# HISTORIC AND DESIGN REVIEW COMMISSION

**HDRC CASE NO:** 2022-056  
**ADDRESS:** 555 S ALAMO ST  
**LEGAL DESCRIPTION:** NCB 901 BLK LOT 44, 45 & 46  
**ZONING:** D, H, RIO-3  
**CITY COUNCIL DIST.:** 1  
**DISTRICT:** La Villita Historic District  
**APPLICANT:** James McKnight/Brown & Ortiz, PC  
**OWNER:** Eric Stone/AUTO HOTEL LLC  
**TYPE OF WORK:** Construction of a fitness center, construction of accessory structures, site modifications,  
**APPLICATION RECEIVED:** January 14, 2022  
**60-DAY REVIEW:** Not applicable due to City Council Emergency Orders  
**CASE MANAGER:** Edward Hall

**Historic and Design Review Commission**  
***Design Review Committee Report***

REVISIONS SUBMITTED TO ADDRESS DRC COMMENTS

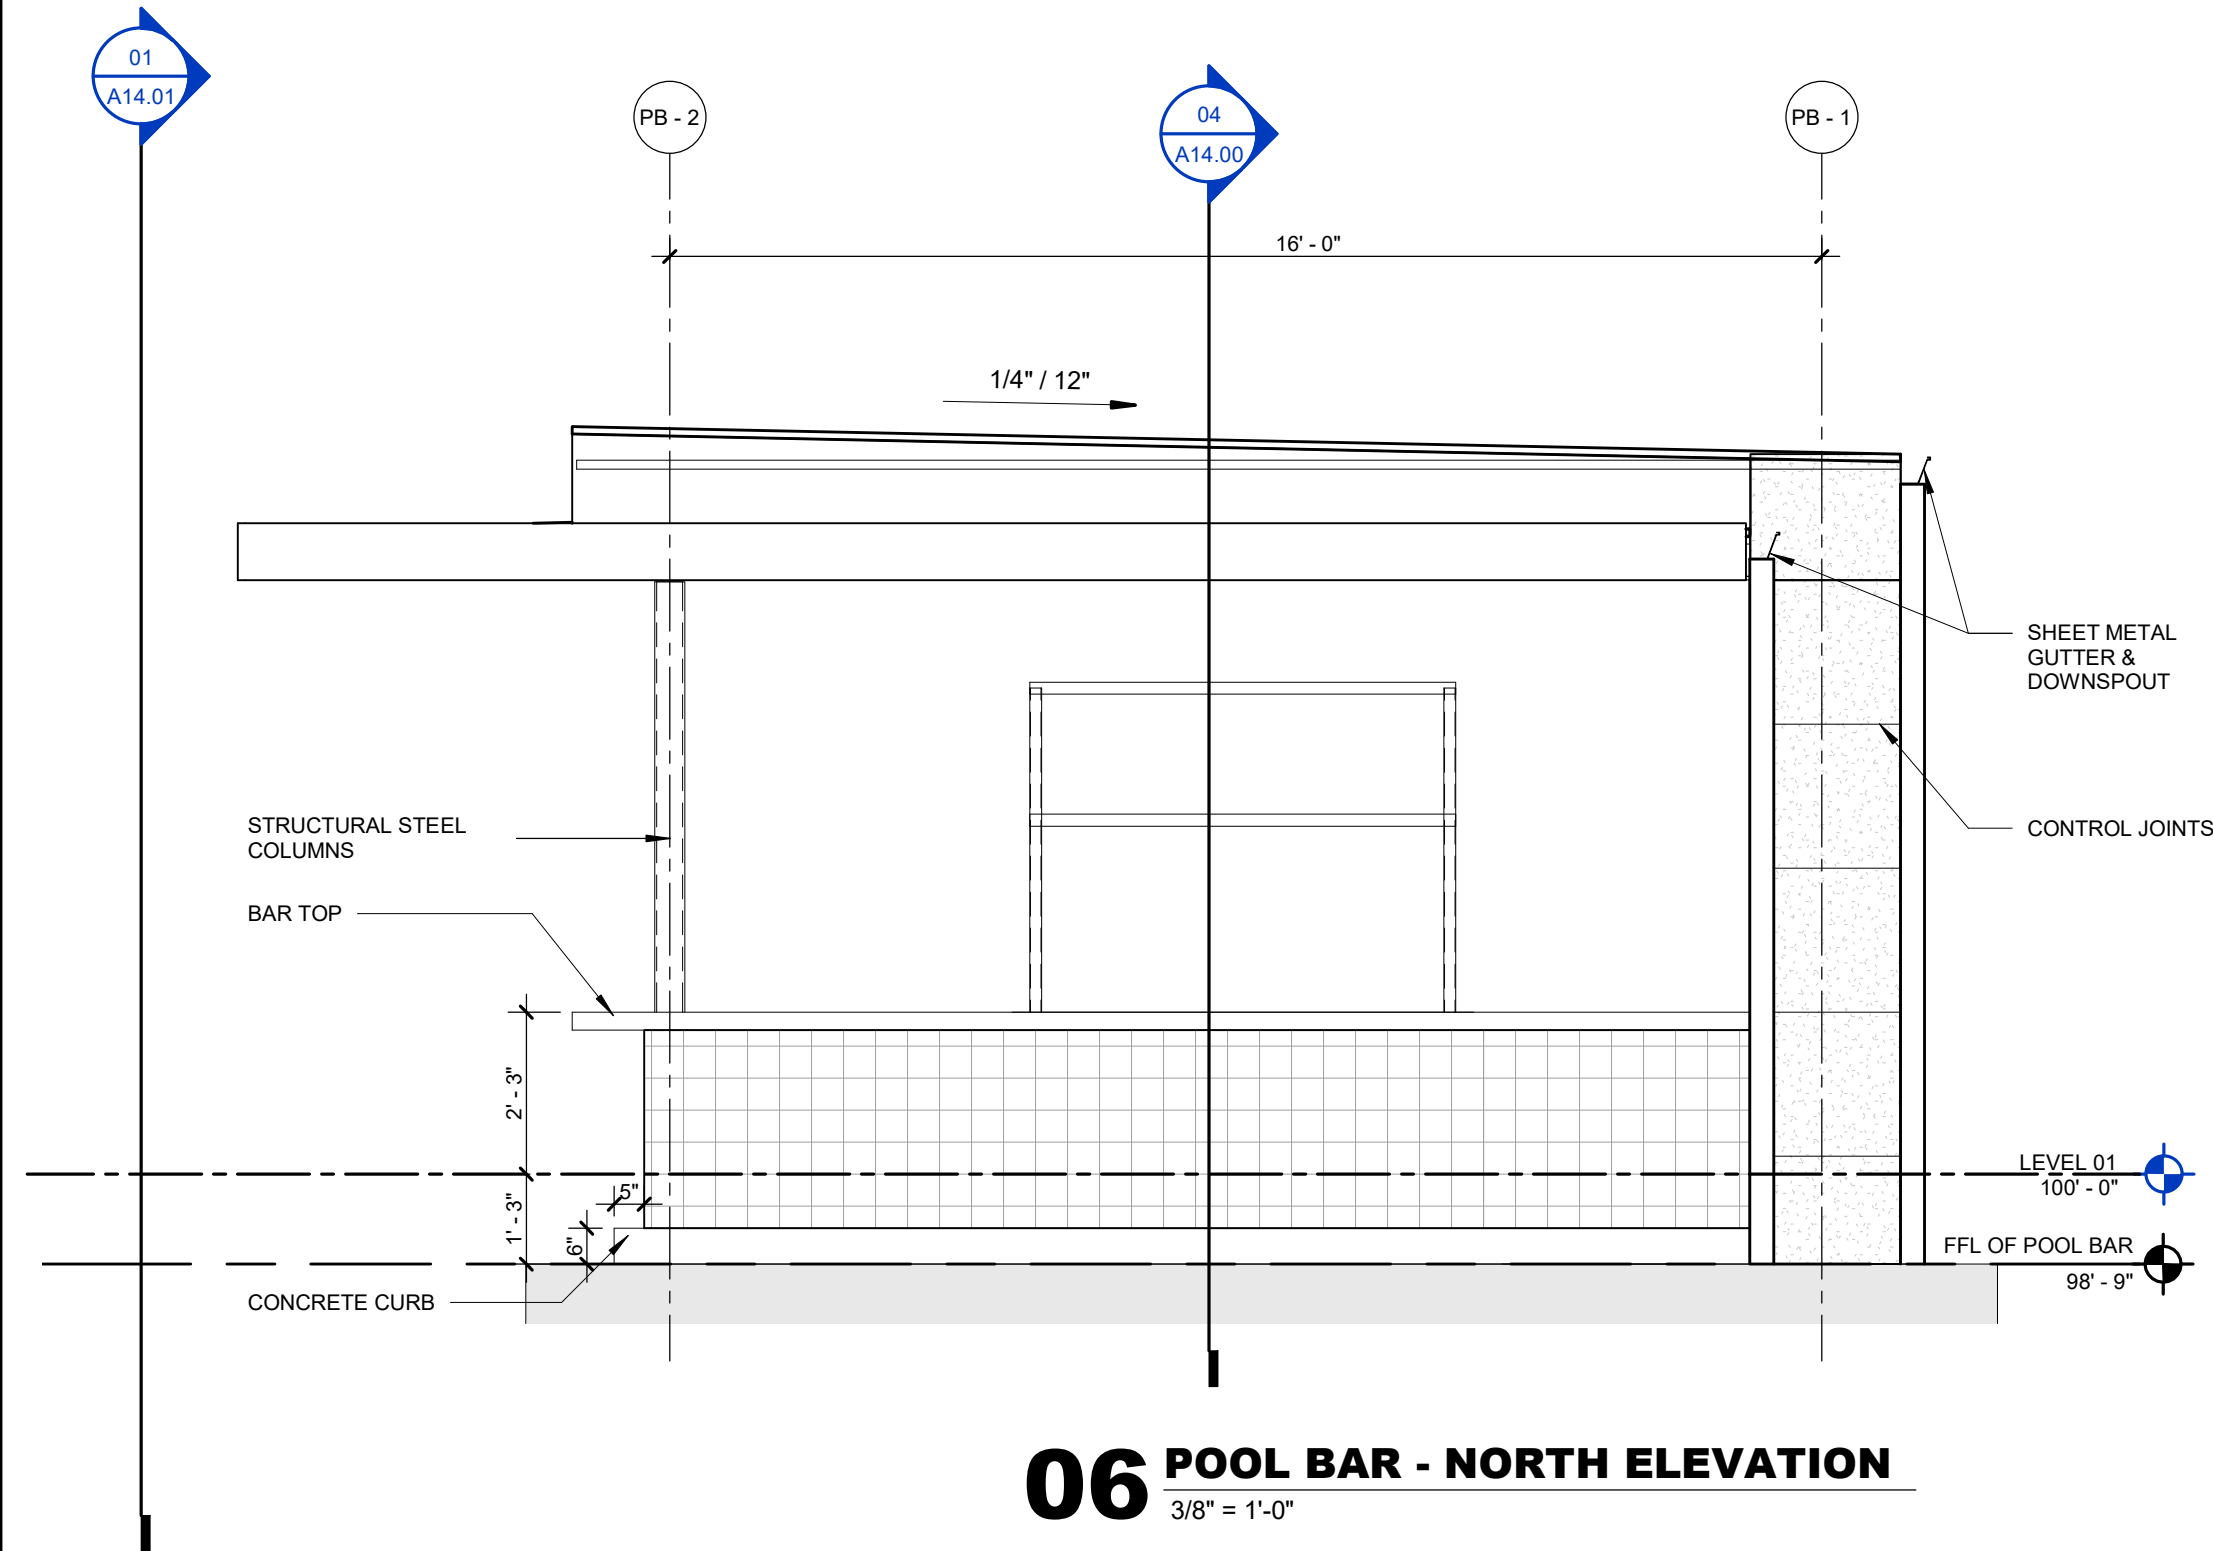
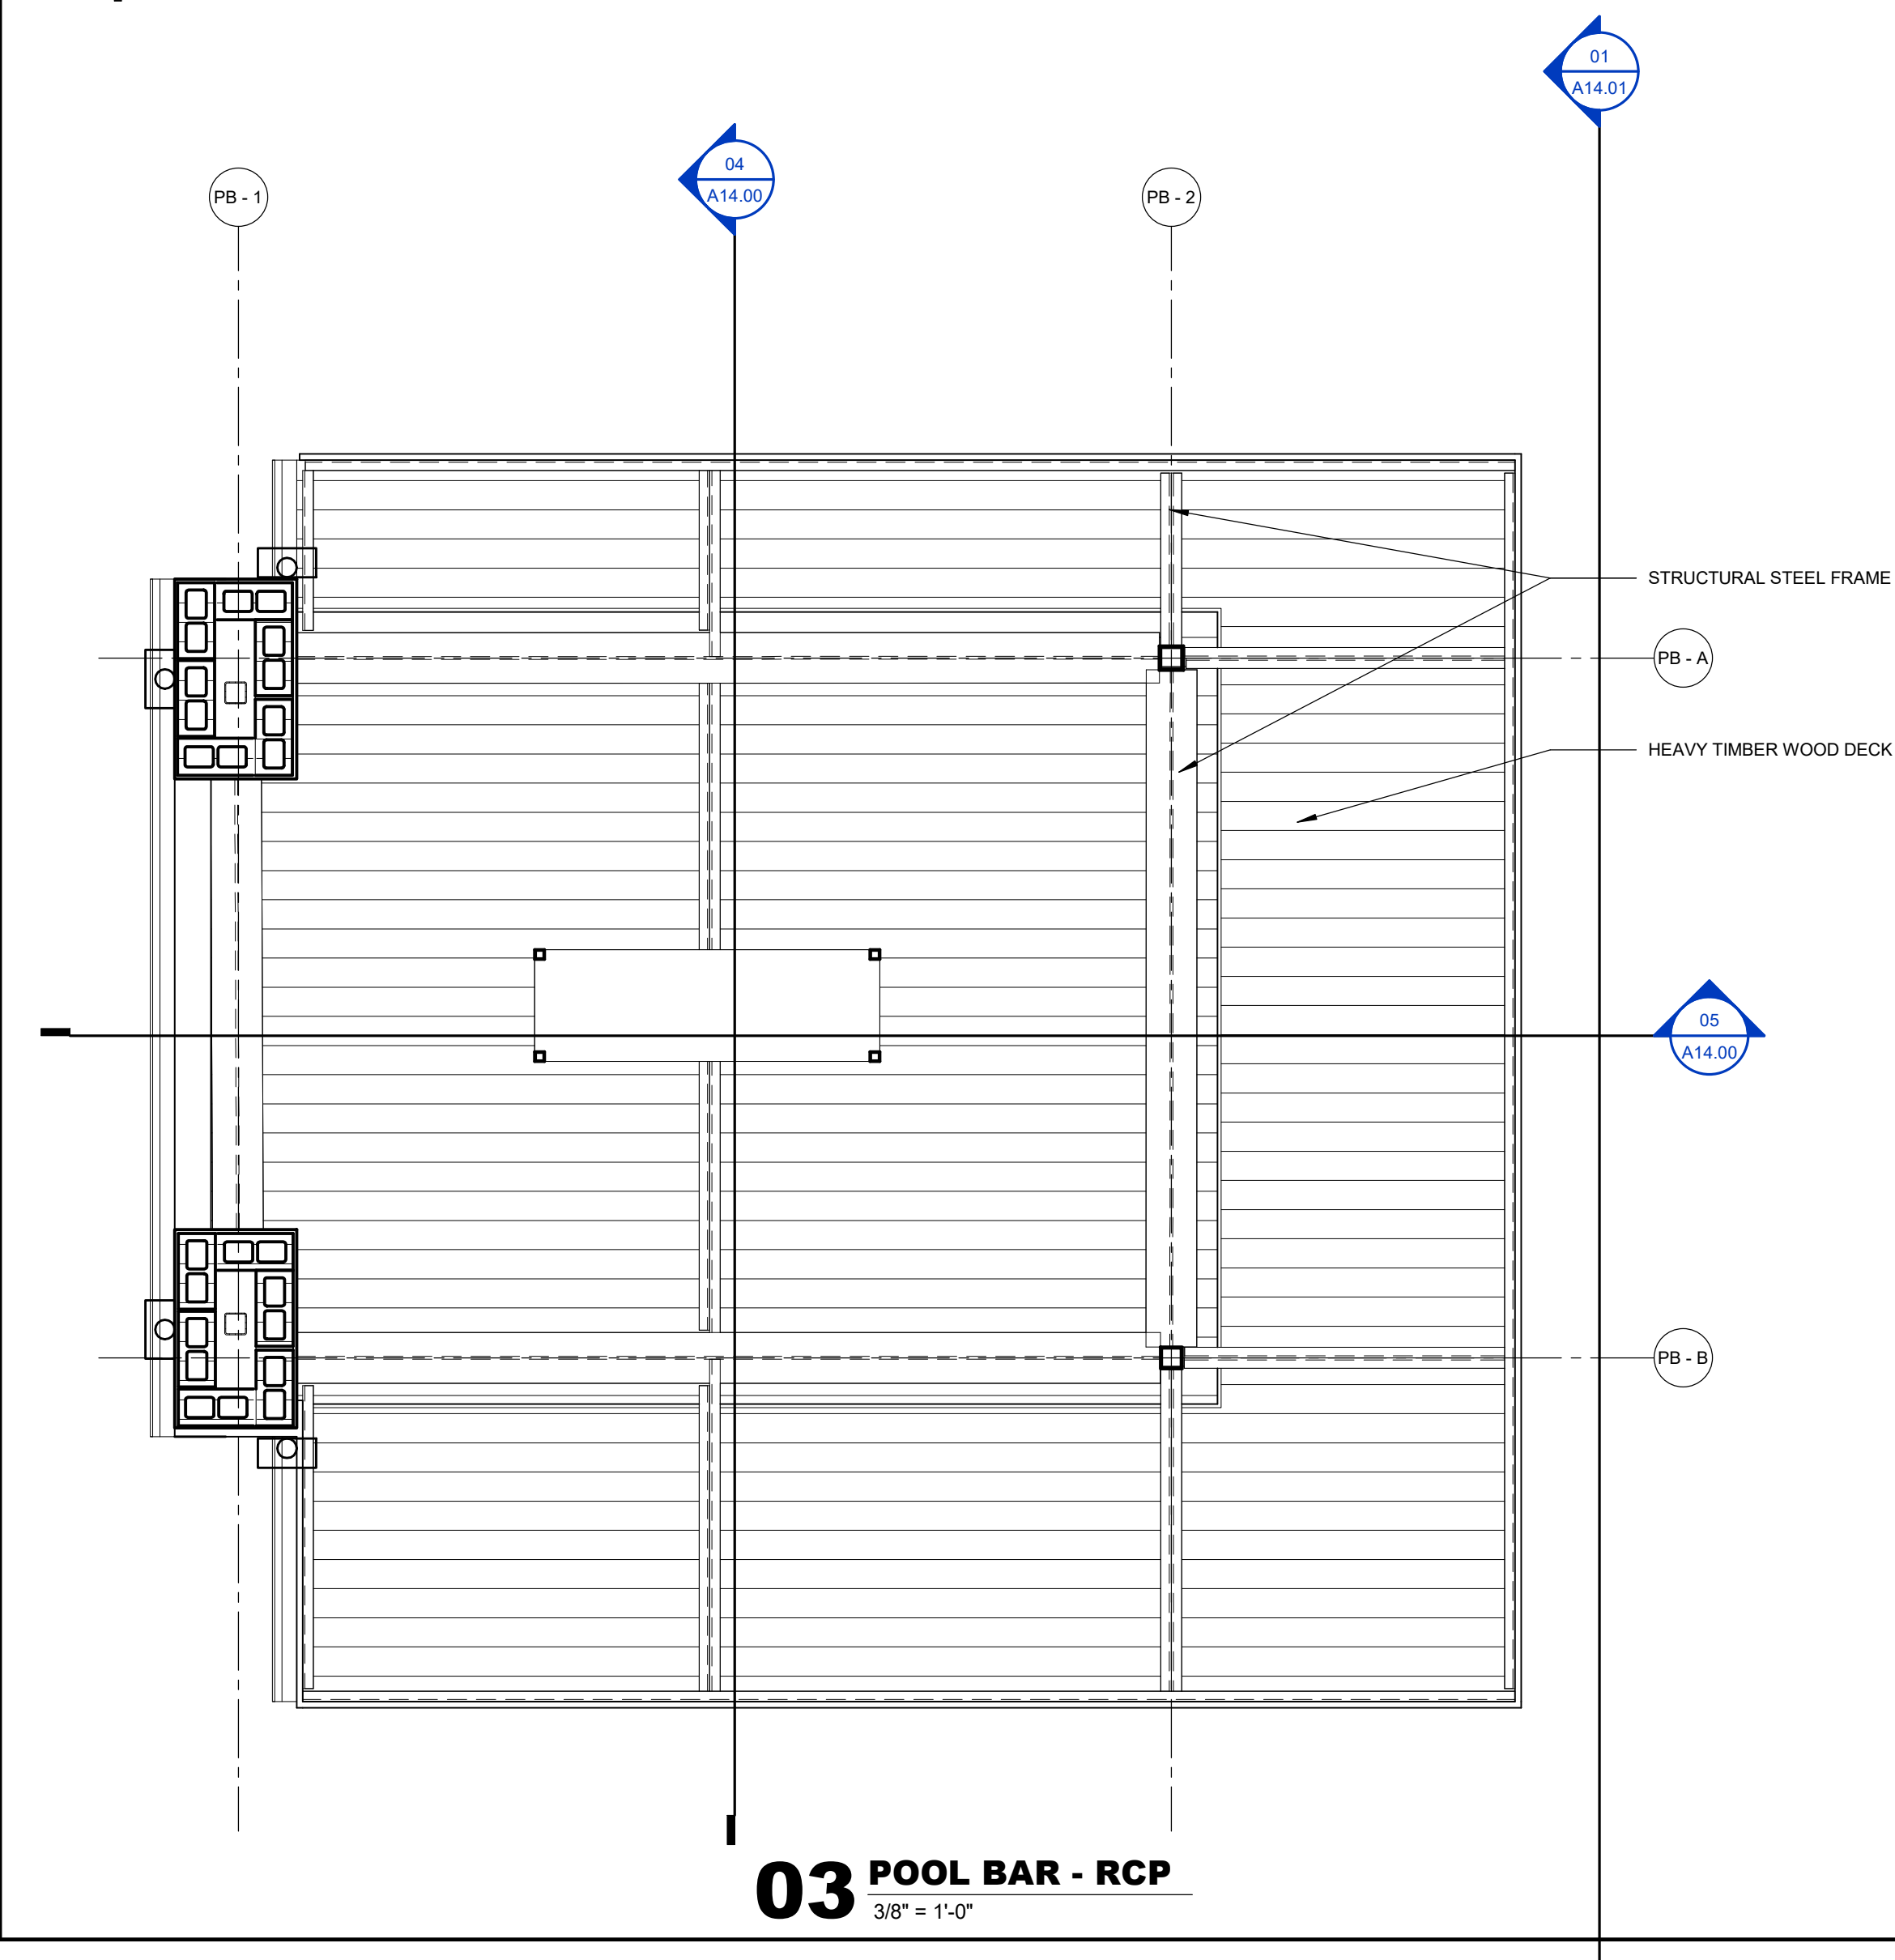
GV: Concerned about the proximity of the roof structure of the pool pavilion to the adjacent historic structure. Does not find the roof plane to be the correct solution.

JF: Study the roof form and the relationship between the north side of the roof in relationship to the historic building – not as much overhang will be needed on the north side.
